**CITY OF BATON ROUGE
PARISH OF EAST BATON ROUGE
DEPARTMENT OF ENVIRONMENTAL SERVICES**

ADDENDUM NO. 4

SUBJECT: **JOOR ROAD / GREENWELL SPRINGS ROAD SEWER AREA UPGRADES
CITY-PARISH PROJECT NO. 11-FM-MS-0023**

TYPICAL TRENCH EXCAVATION & FINAL PAVEMENT REPLACEMENT DETAILS

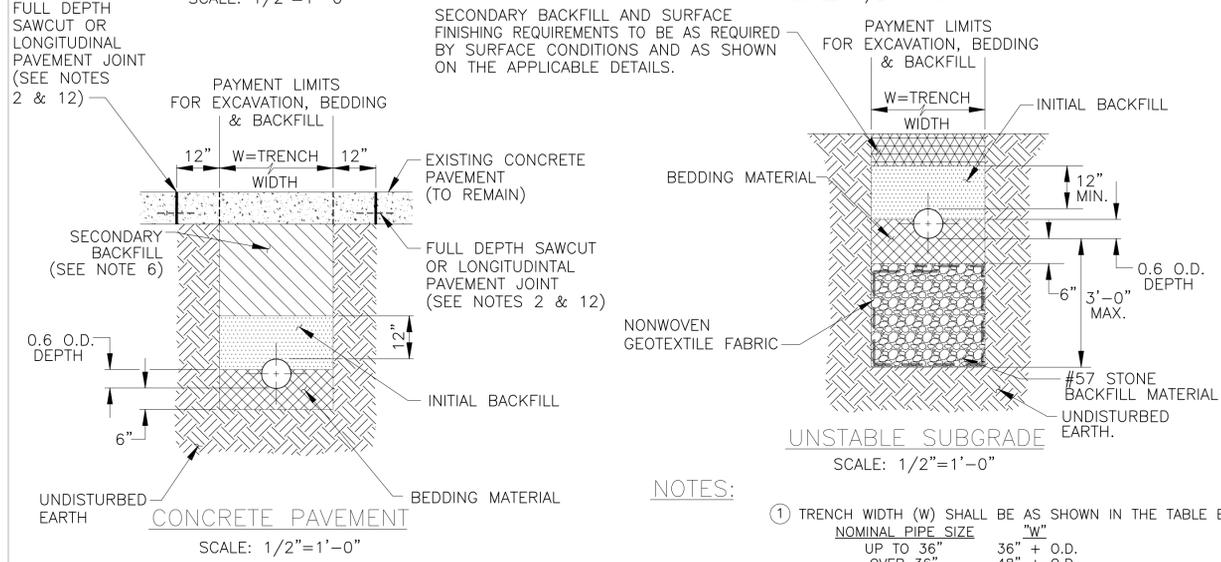
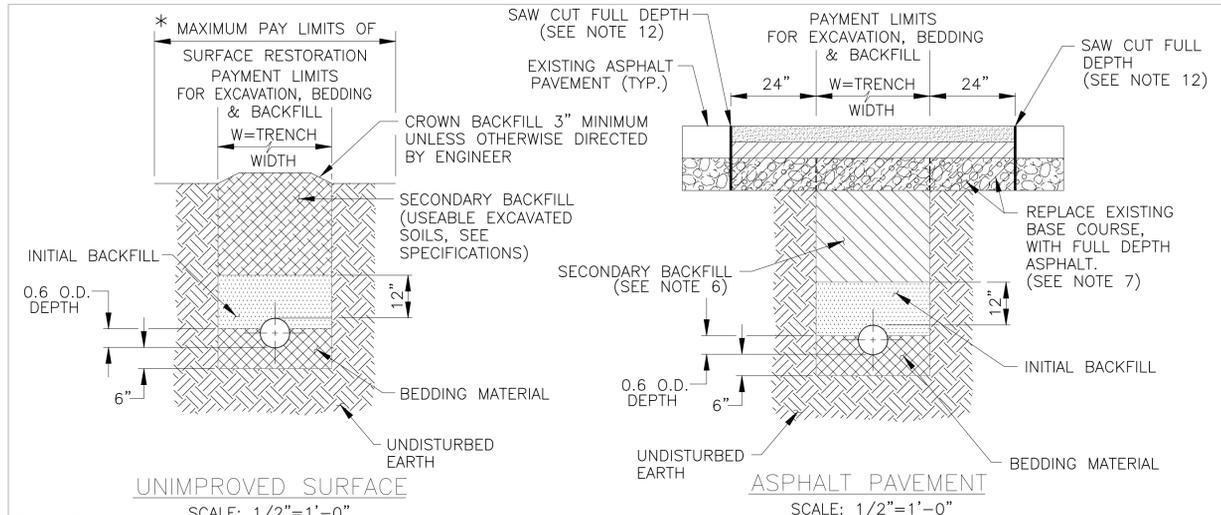
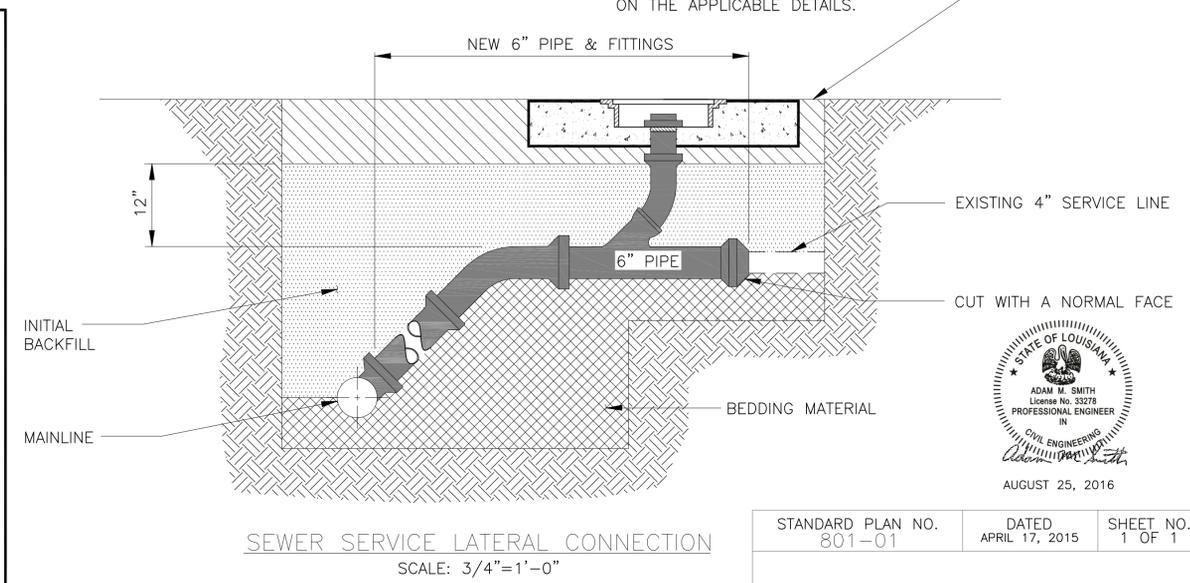
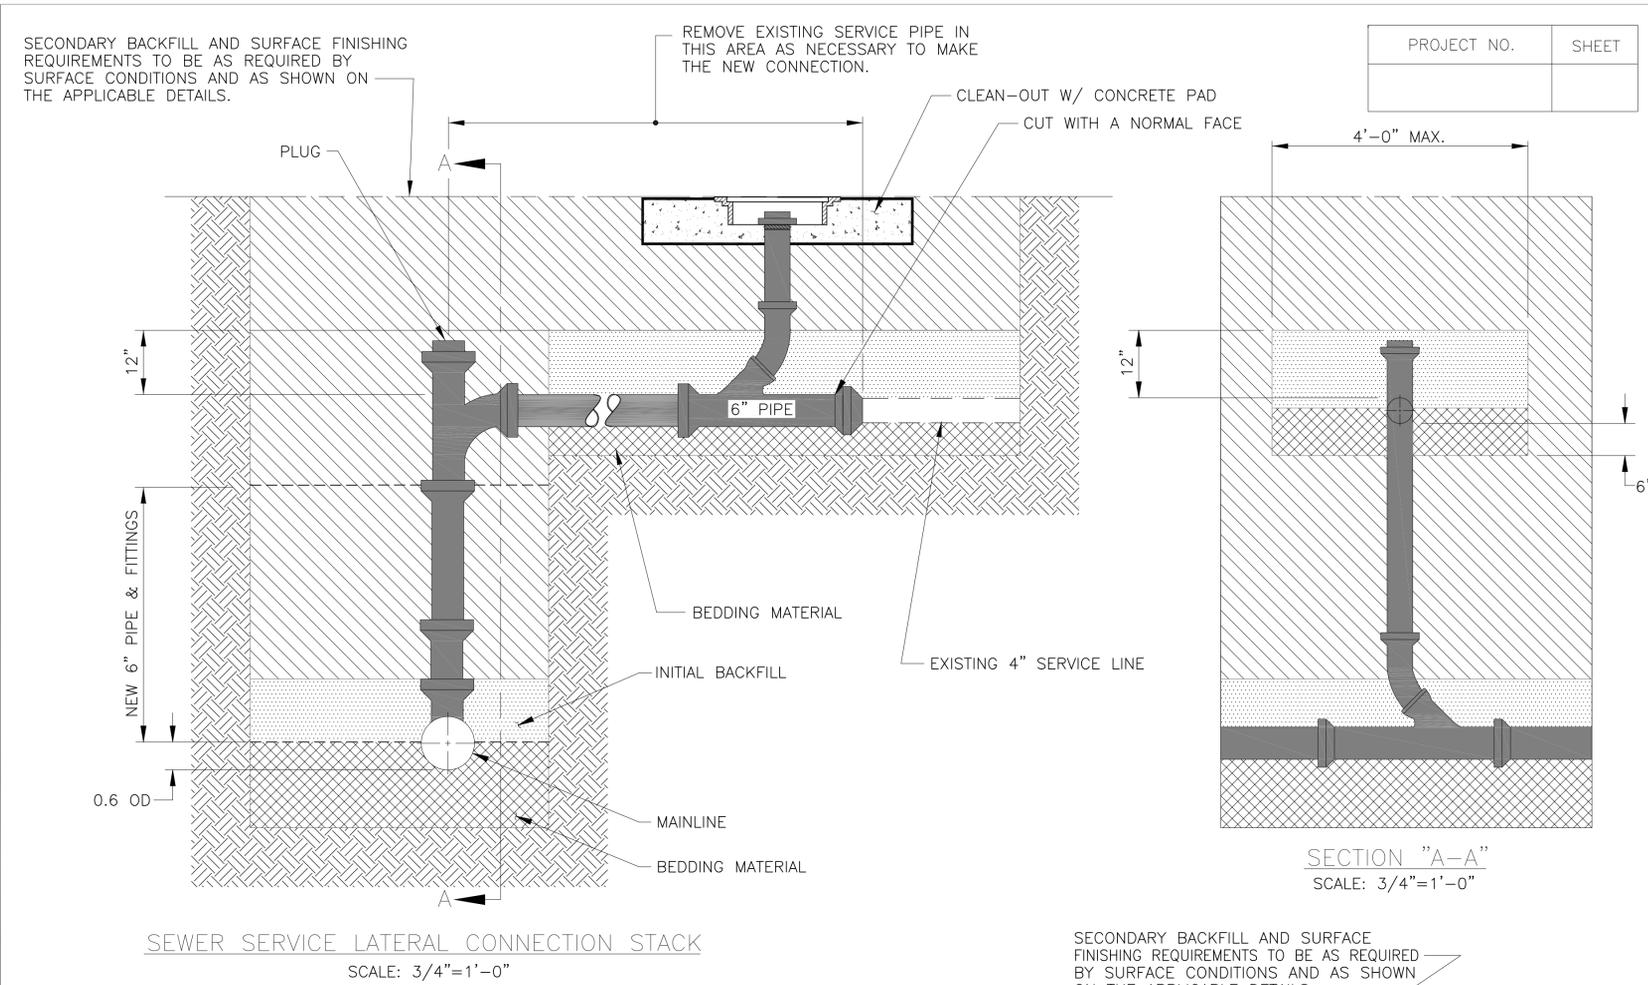
5/16	REVISED TITLE OF UNSTABLE SUBGRADE DETAIL	A.M.S.
4/15	DELETED GEOTEXTILE FABRIC EXCEPT FOR USE WITH #57 STONE AND REVISED GENERAL NOTES.	A.M.S.
4/13	REVISED STACK DETAILS AND REVISED GENERAL NOTES.	A.S.
10/12	ADDED GEOTEXTILE FABRIC ON SEC. BACKFILL	A.S.
DATE	DESCRIPTION	BY
	REVISIONS

FORCE MAIN DETAILS

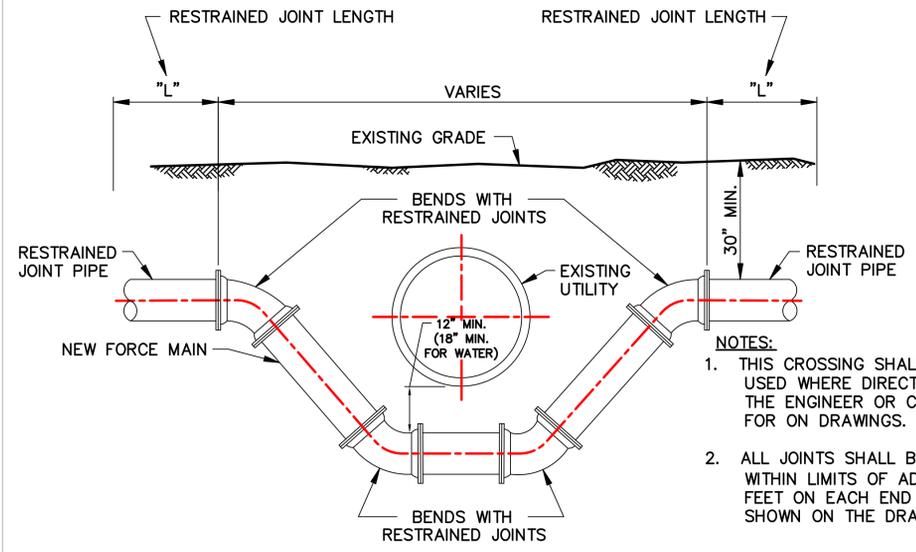
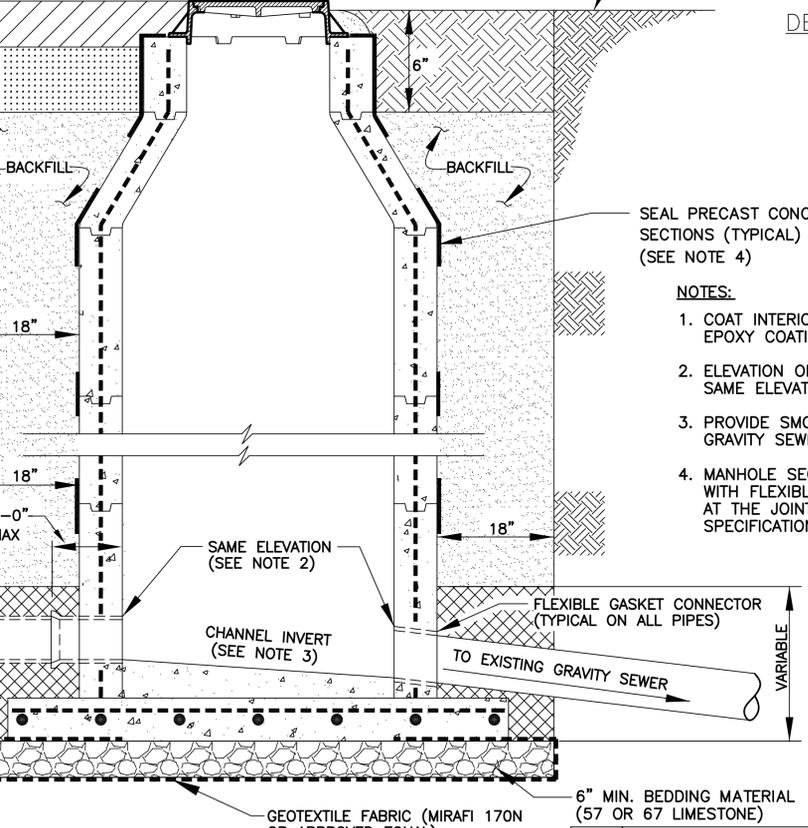
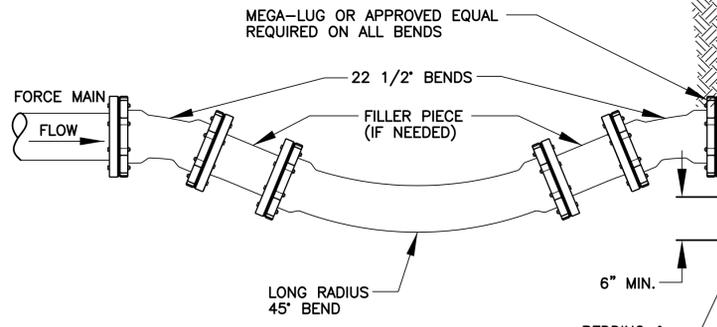
5/16	ADDED GEOTEXTILE TO BEDDING & REVISED NOTE 4	A.M.S.
DATE	DESCRIPTION	BY
	REVISIONS
